**Addendum #1**  
**2020 Roadway Improvement Project**  
**“Cambridge Drive Neighborhood”**  
**Bid No. 20-15**  
**Town of East Hartford**

**February 28, 2020**

The following summarizes the revisions to the Bid Documents included in Addendum #1 for the 2020 Roadway Improvement Project (Bid No. 20-15).

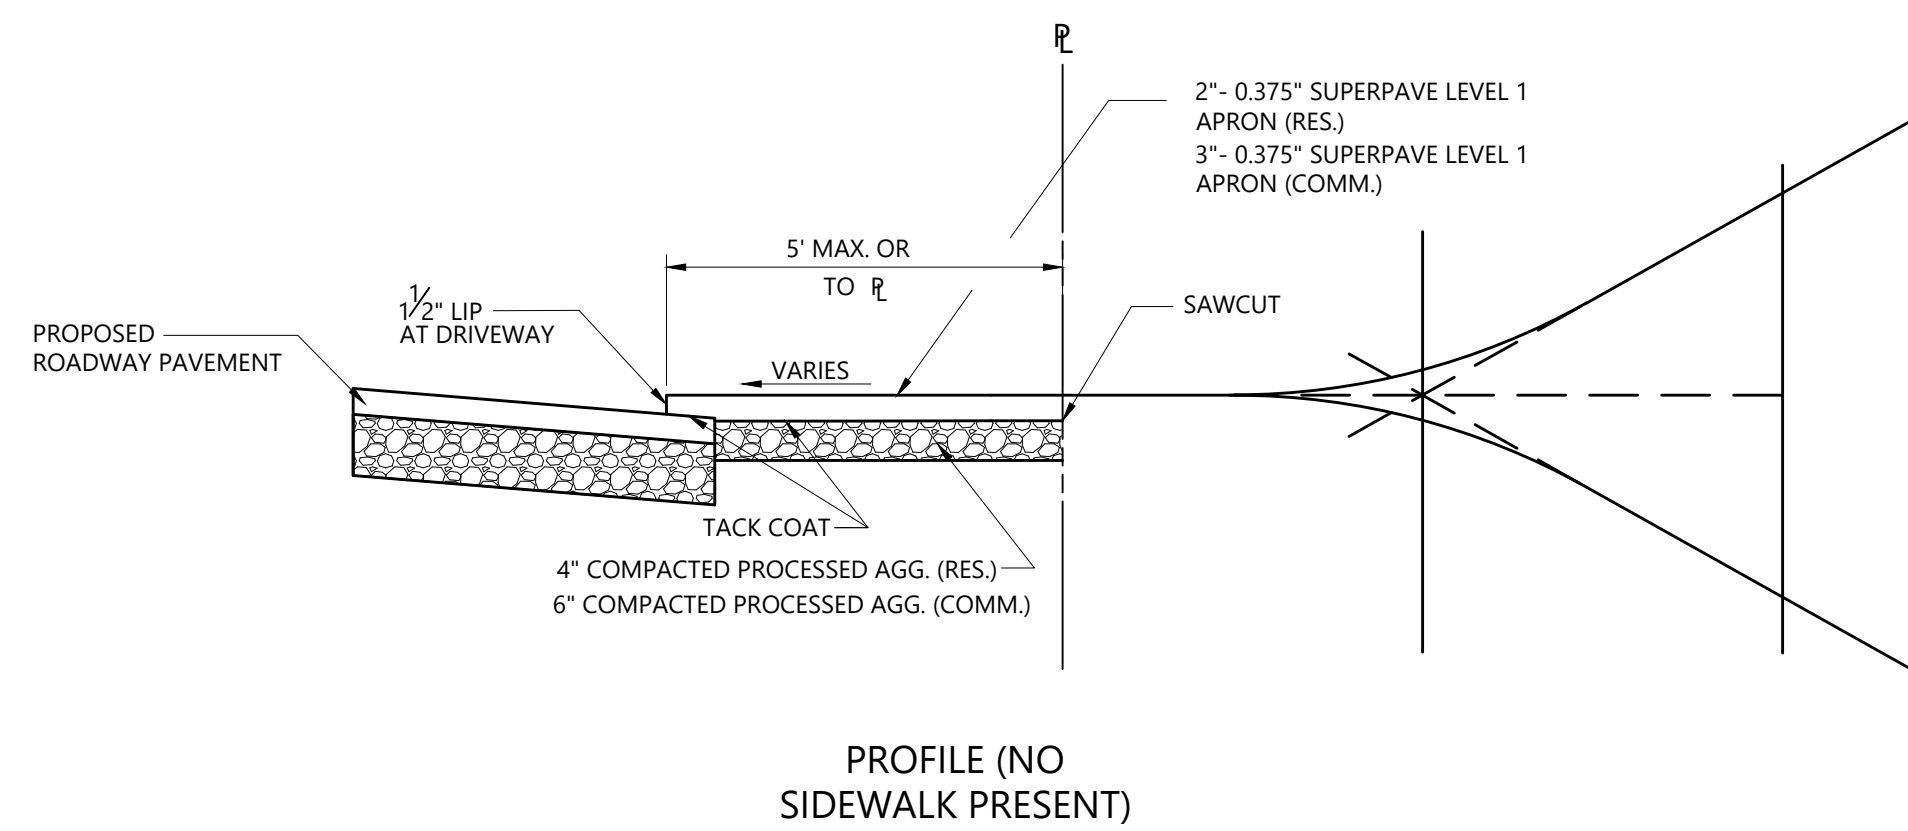
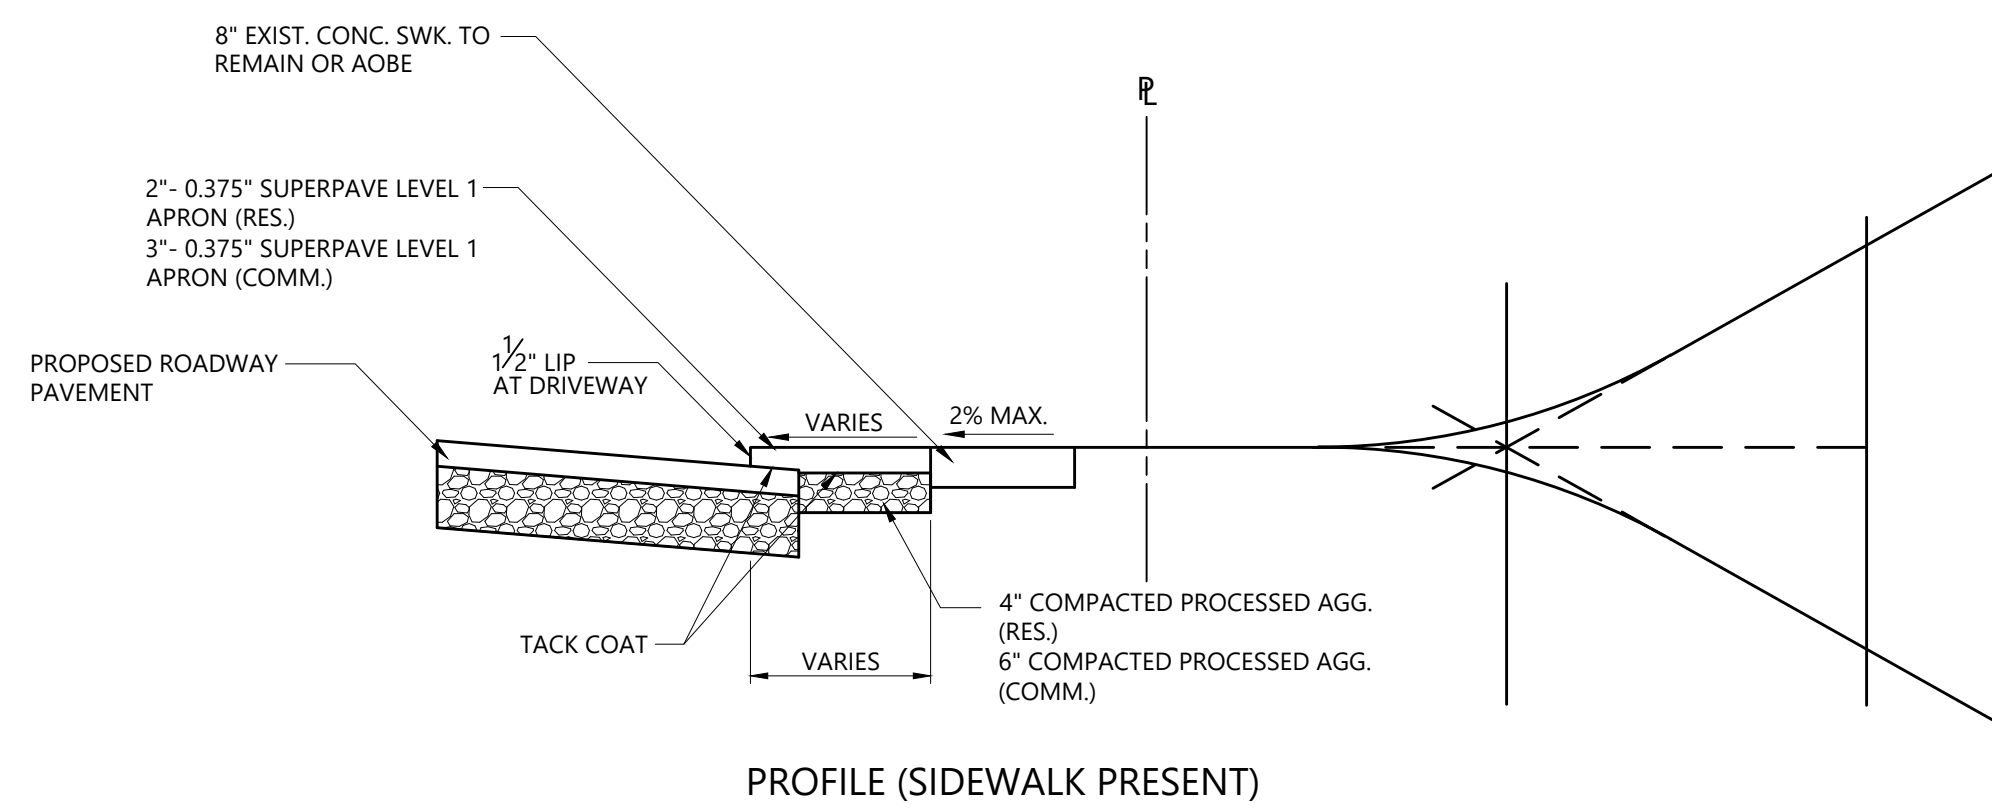
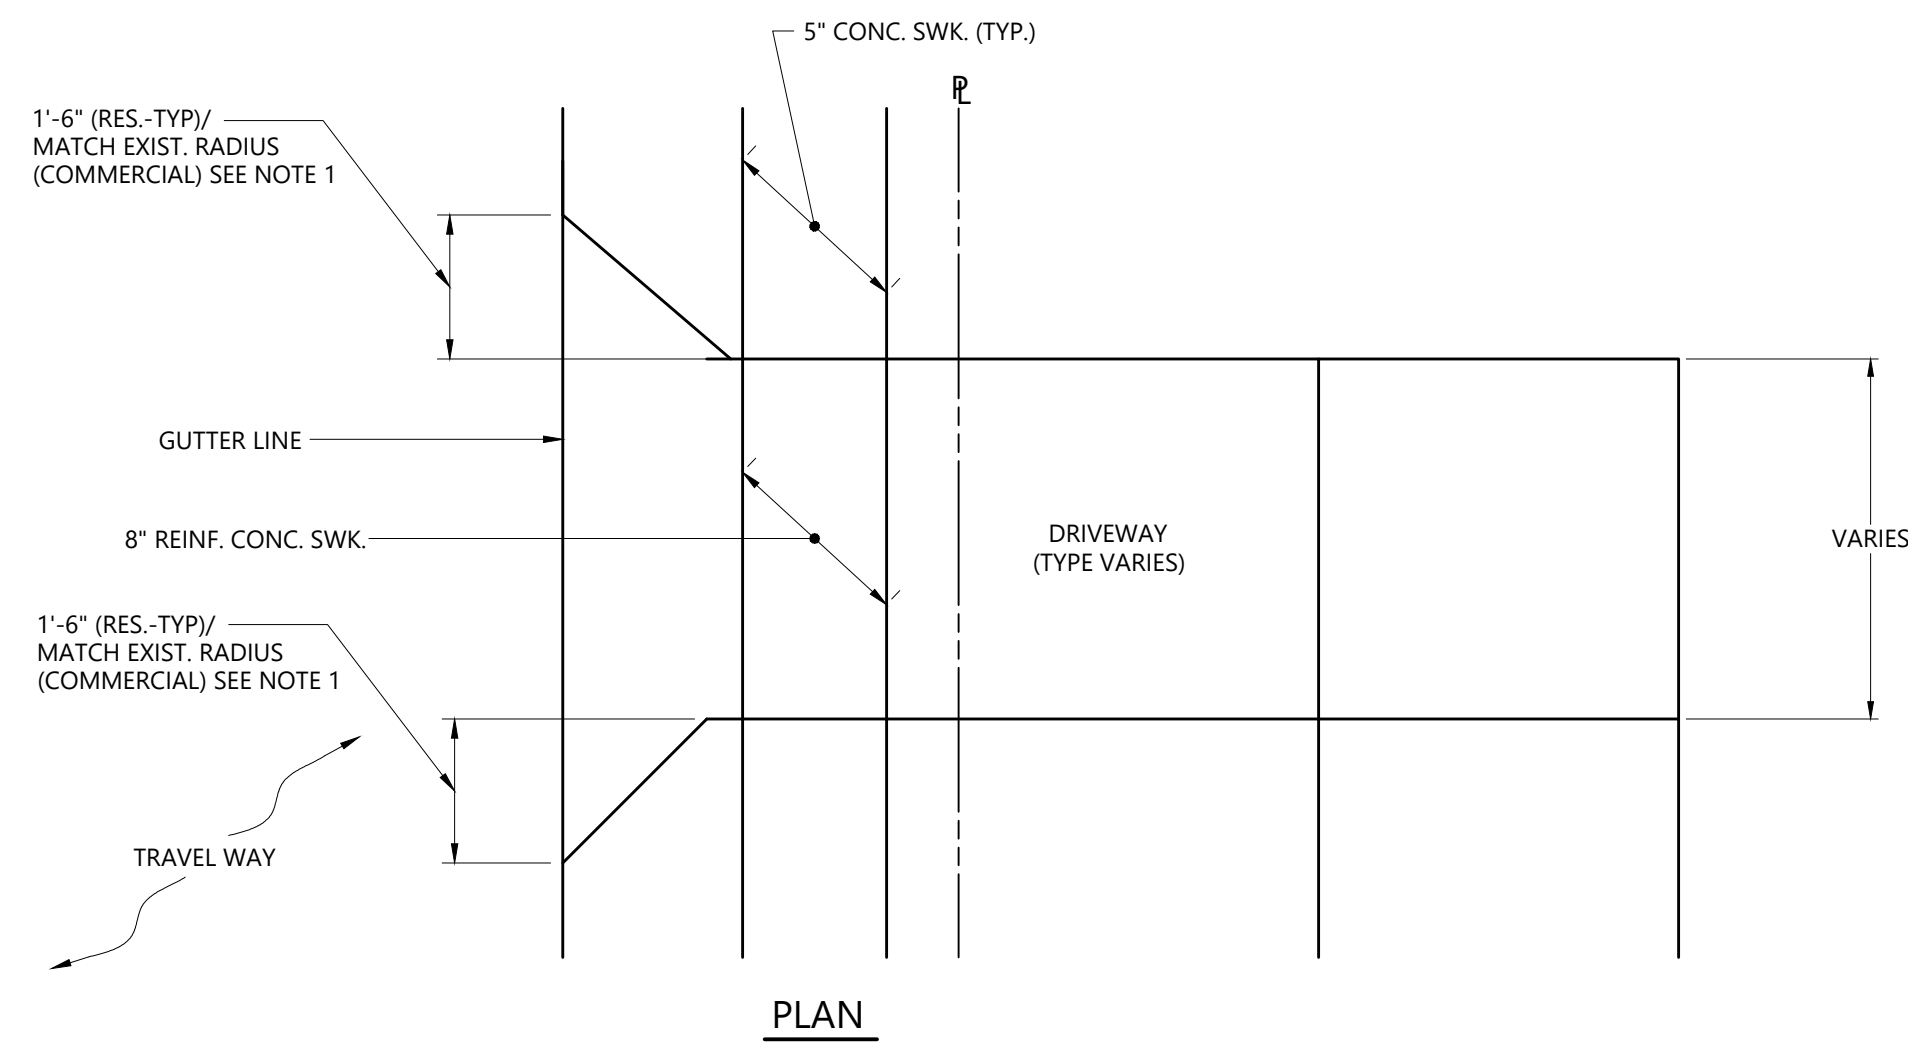
- Replace plan sheet 003 of 294 to reflect the following changes:
  - The addition of the following items:
    - Item #201009A – Removal of Tree – 12" To 24" Caliper
    - Item #201010A – Removal of Tree – Over 24" Caliper
  - Revised quantities for the following items:
    - Item No. 404100A – Partial Depth Patch Repair (Local)
    - Item No. 404200A – Full Depth Patch Repair (Local)
    - Item No. 404300A – Base Patch Repair
    - Item No. 653001 – Clean Existing Catch Basin

- Replace plan sheet 004 of 294 to reflect revised quantities for the following items:
  - Item No. 813001A – 5" Granite Stone Curbing
  - Item No. 813011A – 5" Granite Curved Stone Curbing
  - Item No. 913903 – 10' Chain Link Double Gate 4' High
  - Item No. 921005A – Concrete Sidewalk Ramp
  - Item No. 969062A – Construction Field Office, Medium
